CONTRACT CHANGE ORDER NO. 4551
SHEET 2 OF 5

MARK	DATE	DESCRIPTIONS	BY	CH'D	CCO#
4	03/25/11	HINGE A BARRIER RAIL MODIFICATIONS	TH	GB	25S1
3	10/22/10	HINGE A BARRIER RAIL MODIFICATIONS	TH	GB	25S1
2	01/30/09	HINGE A BARRIER RAIL MODIFICATIONS	TH	AB	25S1
1	03/28/08	HINGE A BARRIER RAIL MODIFICATIONS	TH	AS	25S1

SAN FRANCISCO OAKLAND BAY BRIDGE
EAST SPAN SEISMIC SAFETY PROJECT
SELF-ANCHORED SUSPENSION BRIDGE
(SUPERSTRUCTURE & TOWER)

BARRIER DETAILS NO.5

SAN FRANCISCO OAKLAND BAY BRIDGE
EAST SPAN SEISMIC SAFETY PROJECT
SELF-ANCHORED SUSPENSION BRIDGE (SUPERSTRUCTURE & TOWER)
BARRIER DETAILS NO. 5A

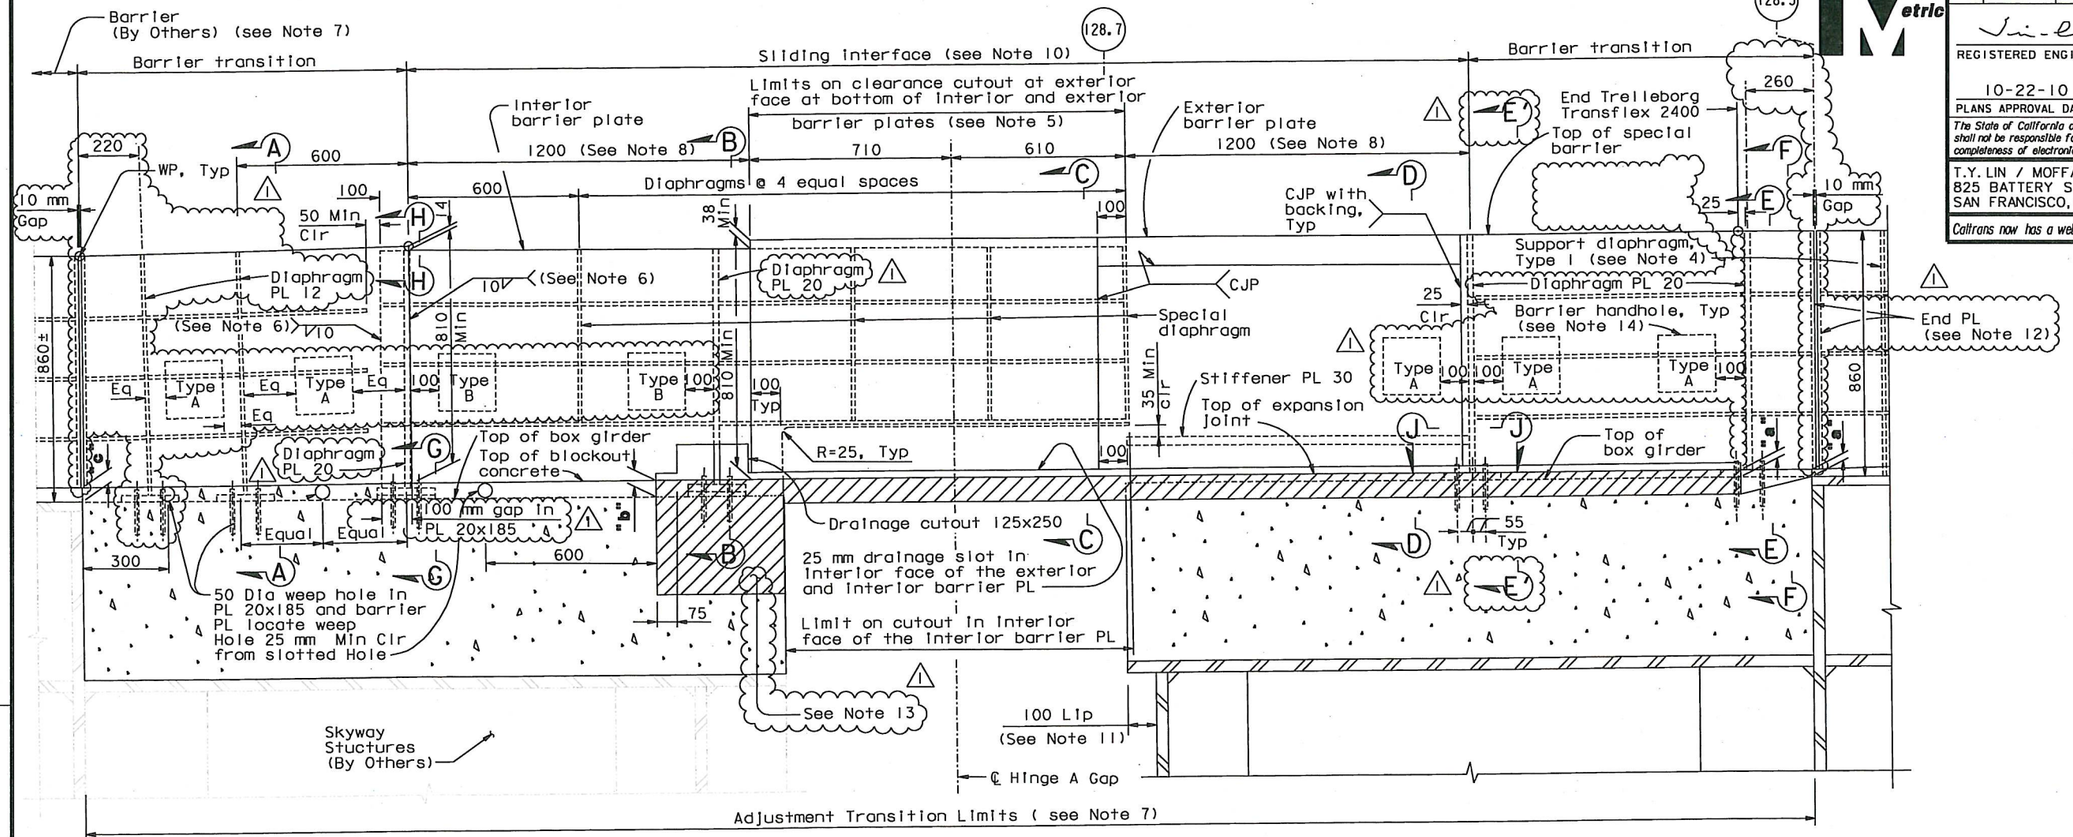
MARK	DATE	REVISIONS	BY	CH'D	CCO#
1	03/25/11	HINGE A BARRIER RAIL MODIFICATIONS	TH	GB	25SI
0	10/22/10	HINGE A BARRIER RAIL MODIFICATIONS	TH	GB	25SI

10. The interior and exterior barrier plate at sliding interface shall be parallel to allow for longitudinal movement without binding. At the Contractor's option, the barrier may be detailed straight from PP128.3 to the existing Skyway barrier, subject to review and approval of the Engineer.
11. Barrier on the SAS side shall be trimmed by an amount equal to the amount of field trimming done at the lip.
12. For end plate details, see "Barrier Details No.2" sheet.
13. At the Contractor's option, it is acceptable to block out concrete and pour a non-shrink grout pad under base after setting alignment, subject to review and approval by the Engineer. All anchor bolts to be tightened after grout attains a minimum compressive strength of f'cl = 75% f'c.
14. Barrier handholes are on the exterior face. For details, see "Barrier Details No.6A" sheet.

7. Field verify the as-built condition and dimensions before fabricating SAS barrier.
8. Values are for mean temperature of 20°C.
9. Unless noted otherwise where calculated overlay at shoulder is greater than 50, overlay shall be tapered to 50 at barrier outside the "Adjustment Transition Limits" to maintain 810 min above the overlay at the barrier.

BARRIER DETAILS NO. 6

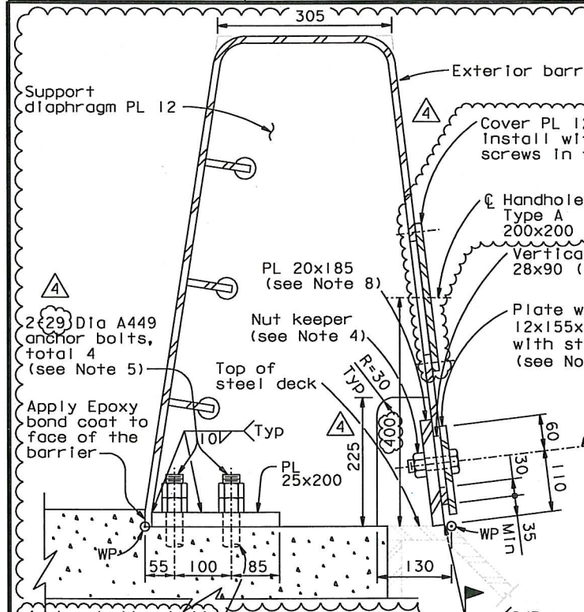
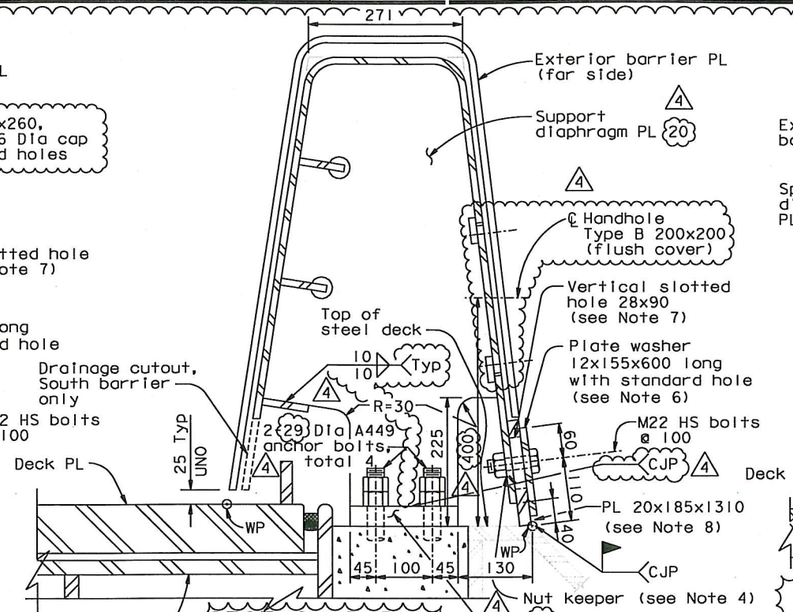
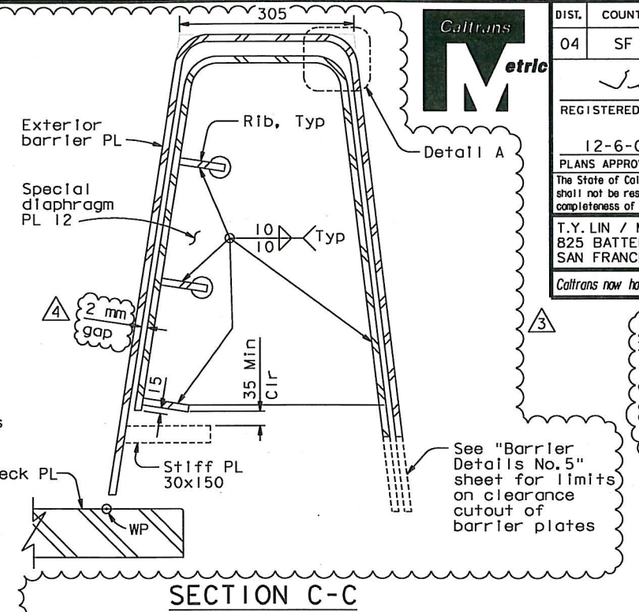
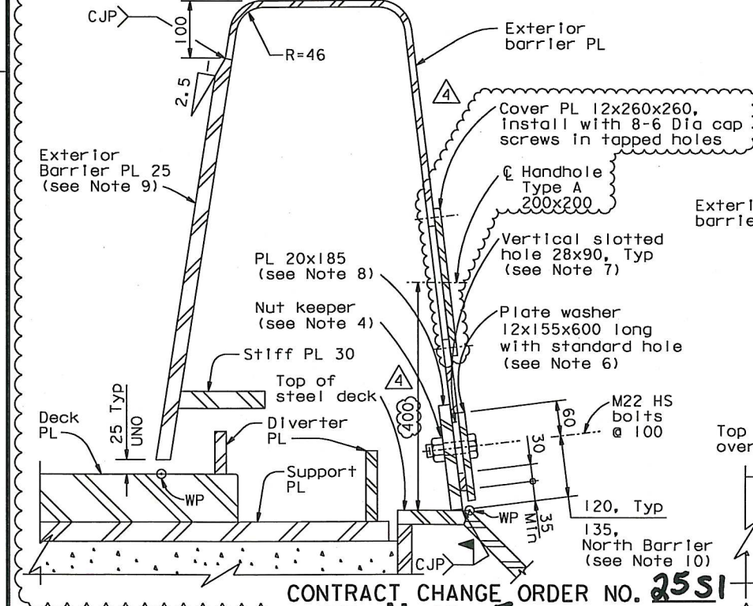
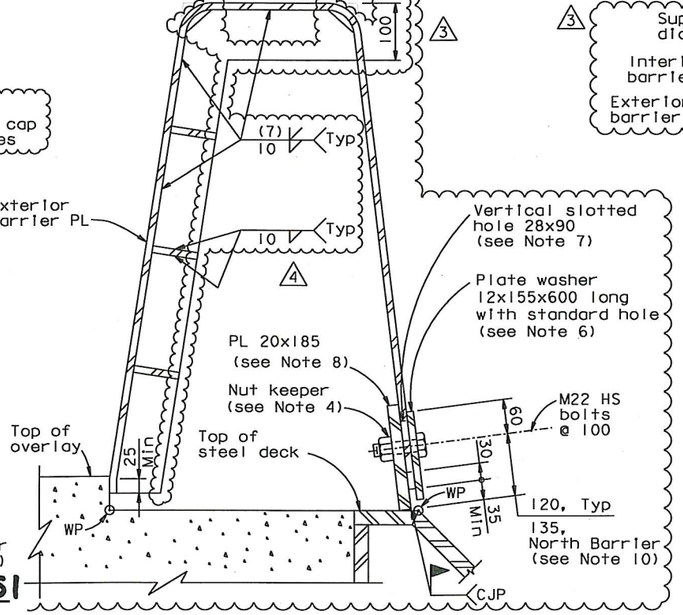
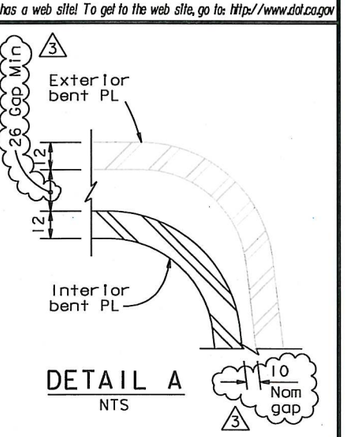
MARK	DATE	DESCRIPTIONS	BY	CH'D	CCO#
4	03/25/11	HINGE A BARRIER RAIL MODIFICATIONS	TH	GB	25SI
3	10/22/10	HINGE A BARRIER RAIL MODIFICATIONS	TH	GB	25SI
2	01/30/09	HINGE A BARRIER RAIL MODIFICATIONS	TH	AB	25SI
1	03/28/08	HINGE A BARRIER RAIL MODIFICATIONS	TH	AS	25SI

5. To access anchor bolts at the support diaphragms, the Contractor may, at his option, provide 200 wide by 400 high handholes with 8mm cover plates with M6 cap screws at the back of the barrier and 100 from the support diaphragms. Anchor bolt nuts may be snug tight plus quarter turn and shall have lock nuts.

6. The plate washer shall be inverted as required to seal the slotted holes when the bolt is moved up or down in the slotted hole.
7. Adjust barrier as necessary utilizing the oversized slot and field weld at barrier transition per "Barrier Details No.5" and "Barrier Details No.5A" sheets to achieve required minimum barrier height over riding surface per "Barrier Details No.5" and "Barrier Details No.5A" sheets.

8. Plate may be installed in segments. Segments shall abut end to end and be caulked. Insert shim plate as necessary to compensate for horizontal misalignment between Skyway and SAS. See Alternate Section D-D.

9. For barrier plate thickness end transition detail, see Section J-J on "Barrier Details No.6A" sheet.
10. North barrier and South barrier on SAS shall be set 25 mm and 10 mm higher respectively with the M22 bolt centered in the slotted hole.

11. Add shim PL if necessary to achieve required barrier height.

BARRIER DETAILS NO. 6A

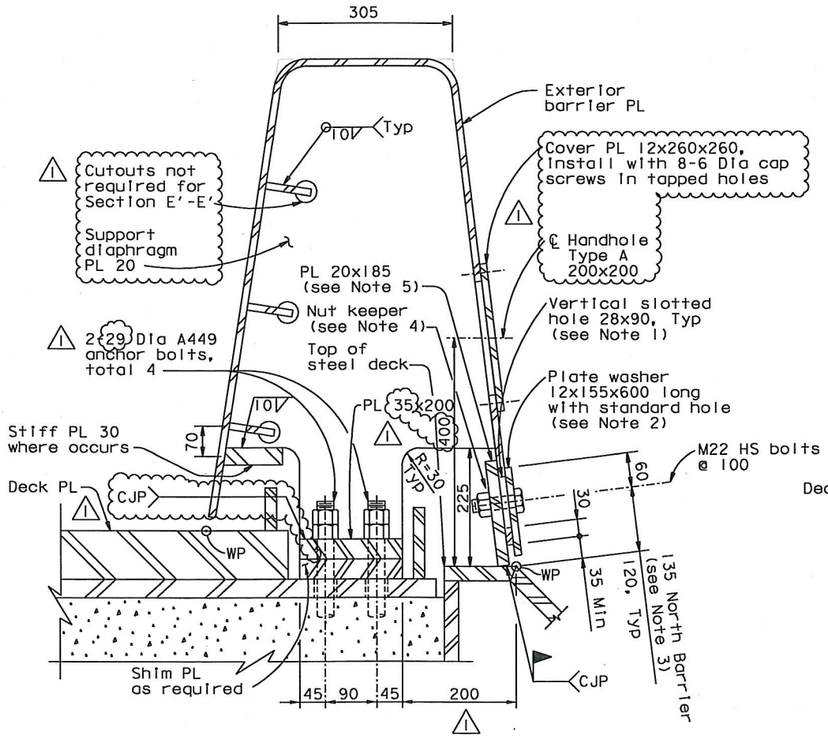
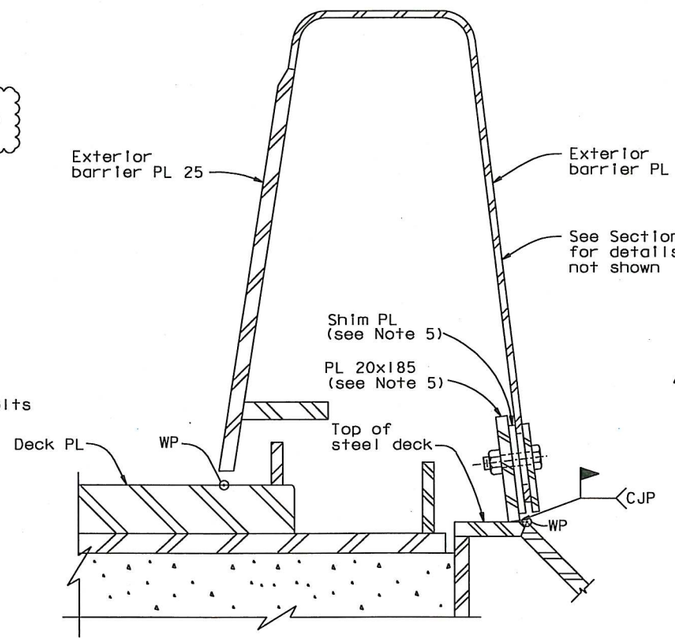
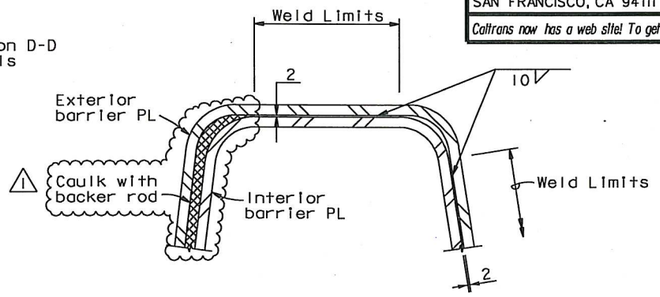
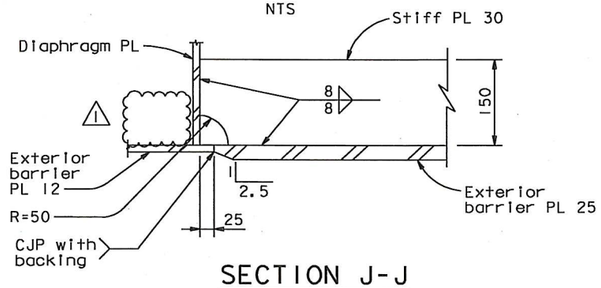
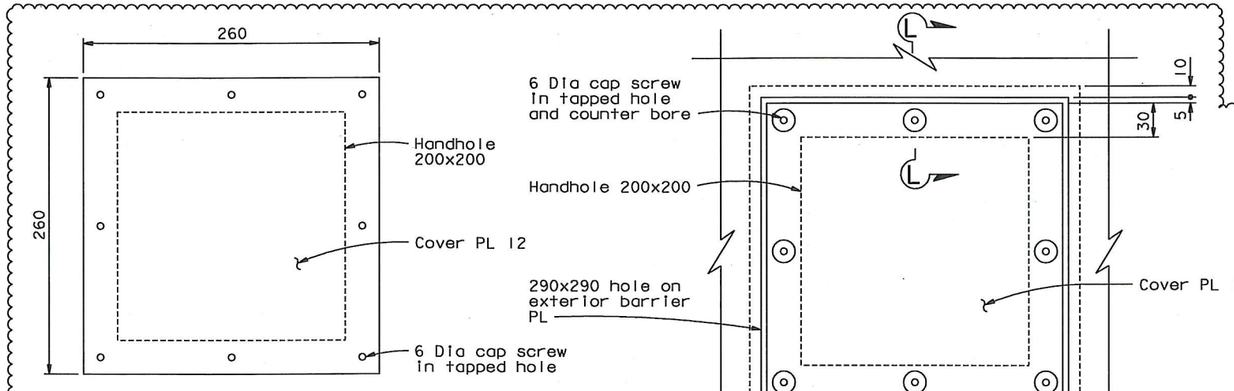
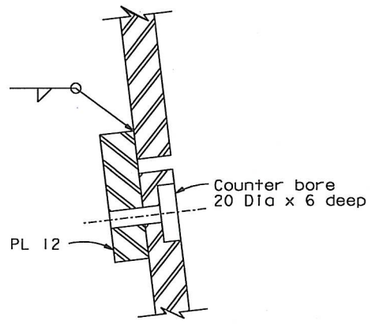
MARK	DATE	DESCRIPTIONS	BY	CH'D	CCO#
1	03/25/11	HINGE A BARRIER RAIL MODIFICATIONS	TH	GB	25S1
0	10/22/10	HINGE A BARRIER RAIL MODIFICATIONS	TH	GB	25S1

1. Adjust barrier as necessary utilizing the oversized slot and field weld to achieve required minimum barrier height over riding surface per "Barrier Details No.5" and "Barrier Details No.5A" Sheets.
2. The plate washer shall be inverted as required to seal the slotted holes when the bolt is moved up or down in the slotted hole.
3. North barrier and South barrier on SAS shall be set 25 mm and 10 mm higher respectively with the M22 bolt centered in the slotted hole.
4. For nut keeper details, see "West Jacking Frame Details No.1" sheet.
5. Plate may be installed in segments. Insert shim plate as necessary to compensate for horizontal misalignment between Skyway and SAS.
